<b>IDMC, ANAND</b>	<b>CORRIGENDUM-I Dt. 15.12.2025</b>	<b>TENDER REF: IDMC/ Sourcing &amp; VD/ 2025-26/ Enquiry/ 351</b>
--------------------	---	---

**Description of Work:** Design, supply, fabrication and erection of pre engineering building (PEB) work for multi fruit processing Plant of capacity - 40 MT/Hr. (mango) and 20 MT/Hr. (tomato) " at Mother Dairy Fruit & Vegetable Pvt Ltd Kuppam, Chittoor, Andhra Pradesh

Enclosure: Section X – Revised SOQ

Section XI – Revised site layout – Master plan and drawings of ECRC building

CONTOUR MAP OF MOTHER DAIRY

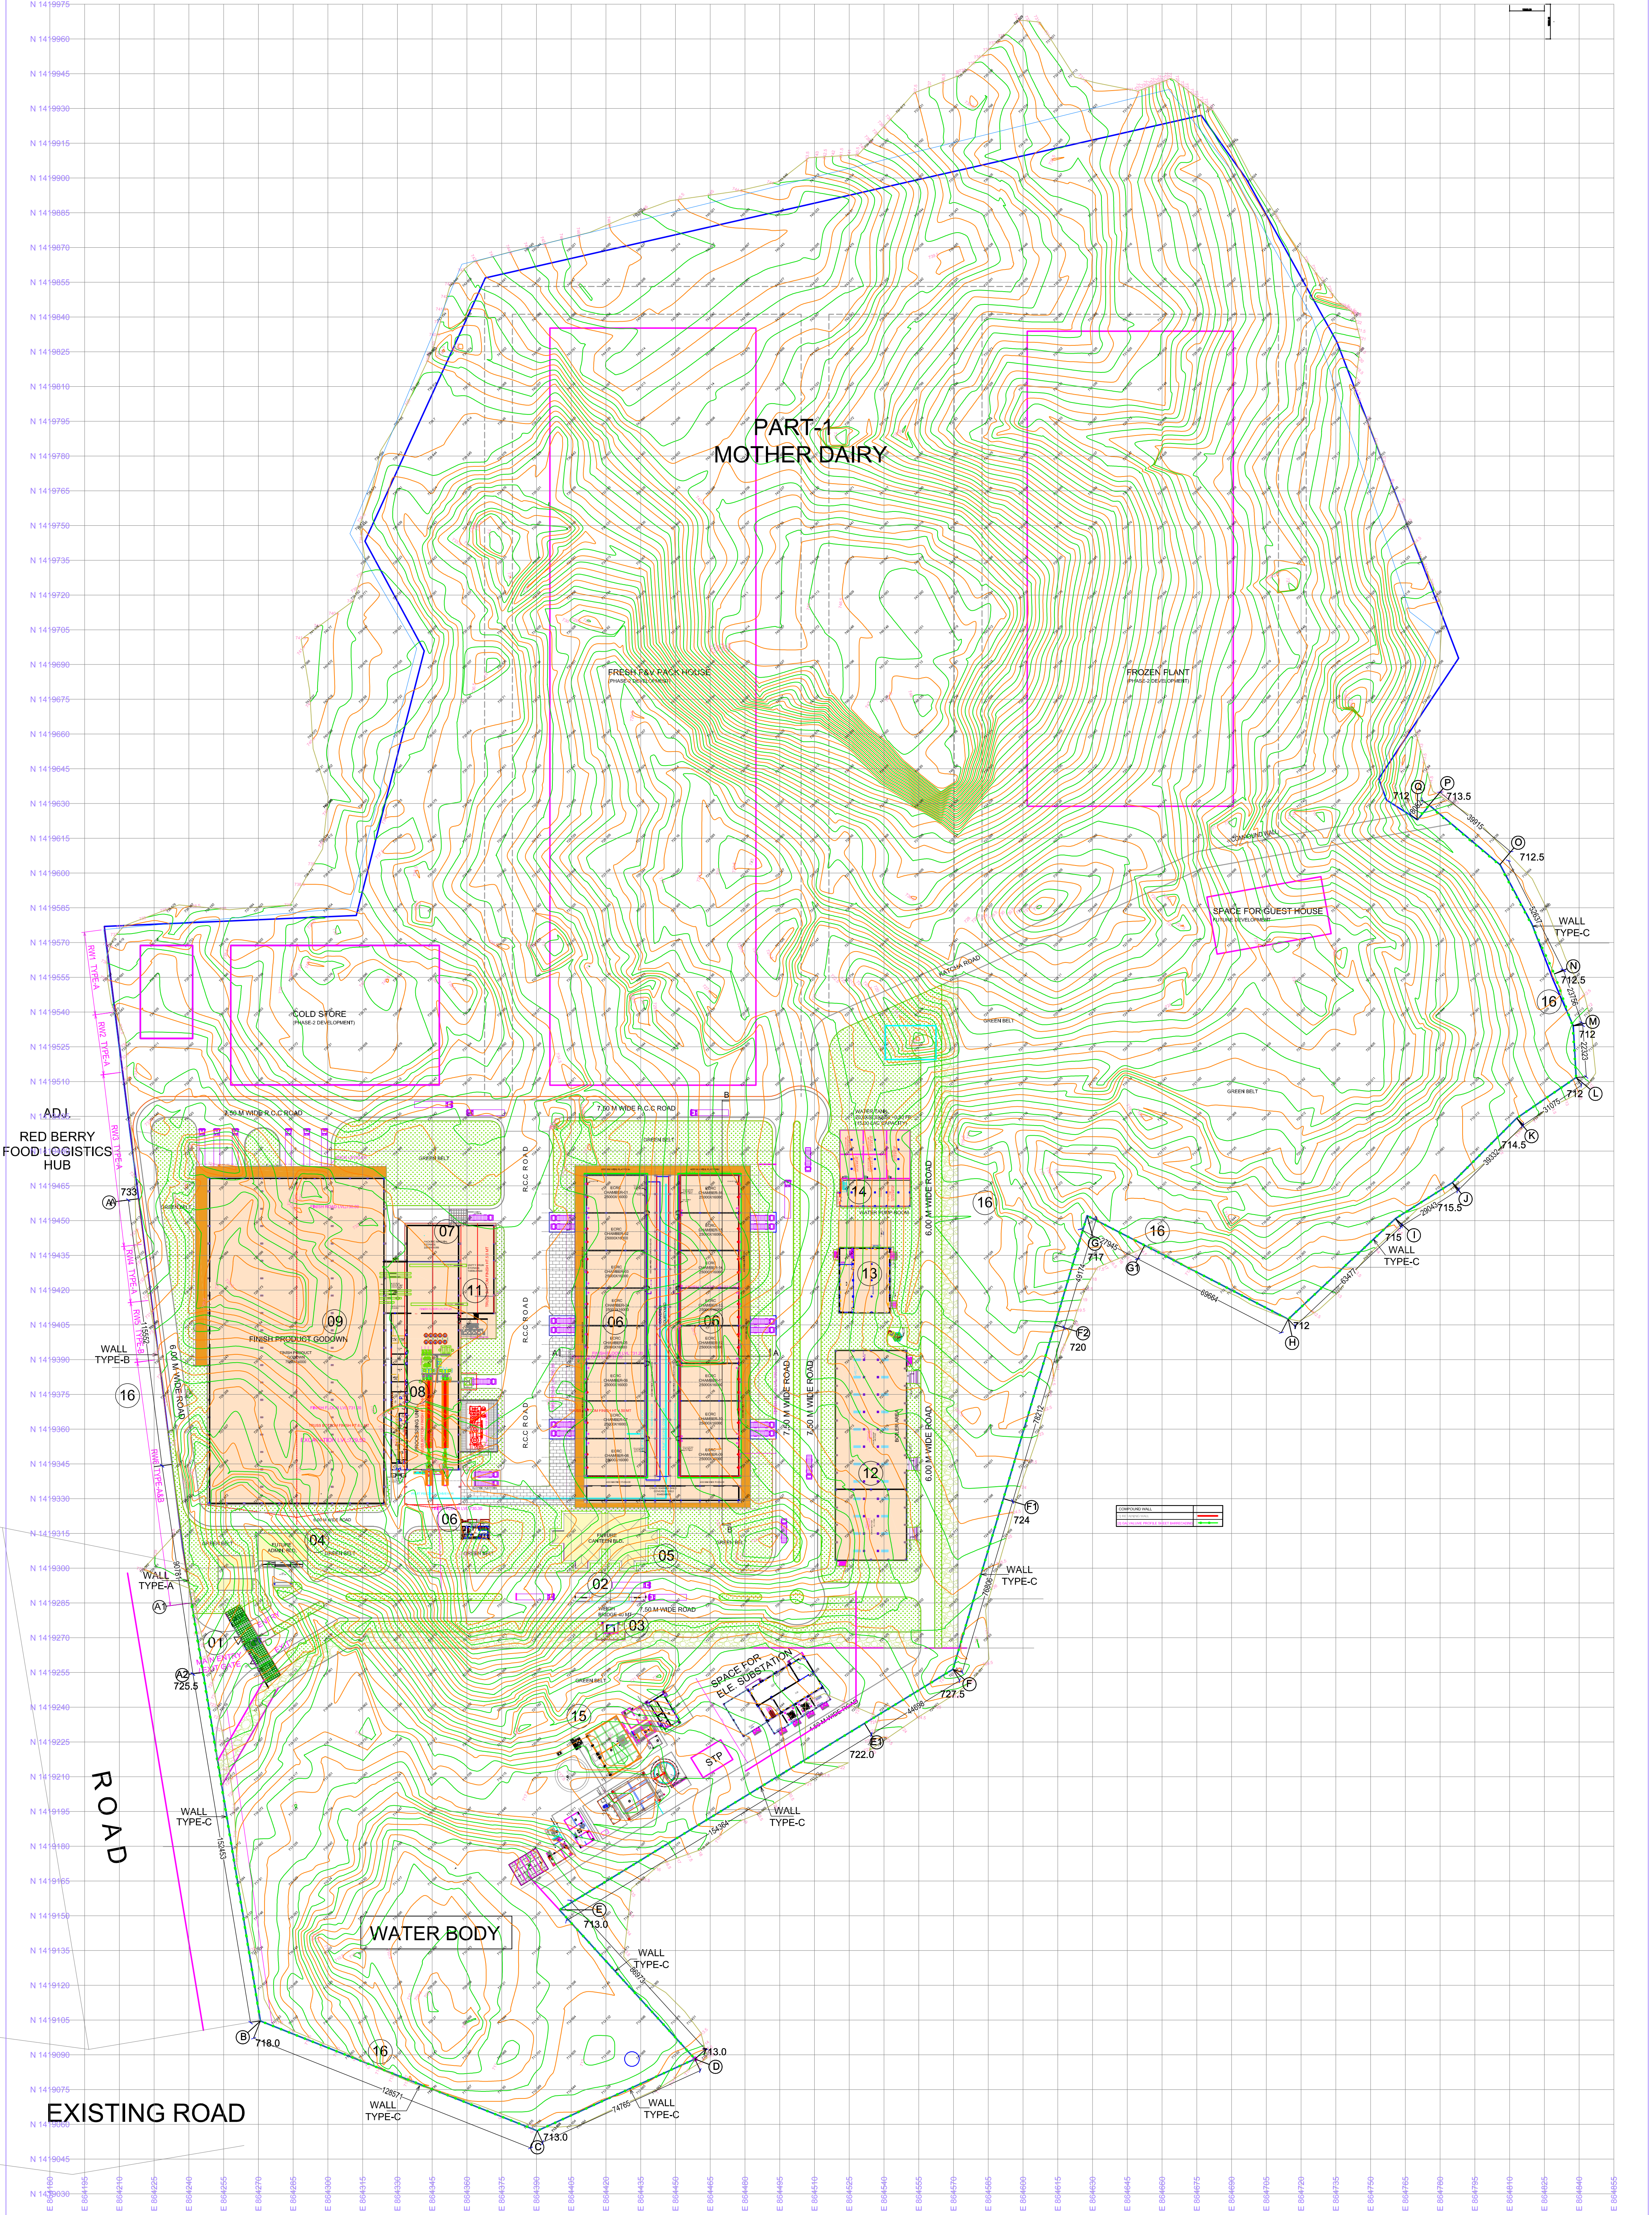
Corrigendum - I			
SI No.	Tender Document Section & Clause	As per the tender document	Please read it as below (Revision)
1	Section 0 Clause No.5 (e), (f), (l)	(e)Event Close Date & time – 16.12.2025, 17.00 Hours  (f)Last Date and time for bid submission - 16.12.2025, 17.00 Hours  (l) Date and time for receipt of EMD - 15.12.2025, 17.00 Hours	(e)Event Close Date & time – 31.12.2025, 17.00 Hours  (f)Last Date and time for bid submission - 31.12.2025, 17.00 Hours  (l) Date and time for receipt of EMD - 30.12.2025, 17.00 Hours
3	Section X	Section XI - Schedule of Quantities - Tender published dated 26.11.2025	Section X - Schedule of Quantities - Revision 1 (enclosed revised SOQ)
4	Section XI	Sketches – General Site Layout - - Tender published dated 26.11.2025	Section XI - Sketches – General Site Layout (enclosed revised site layout)
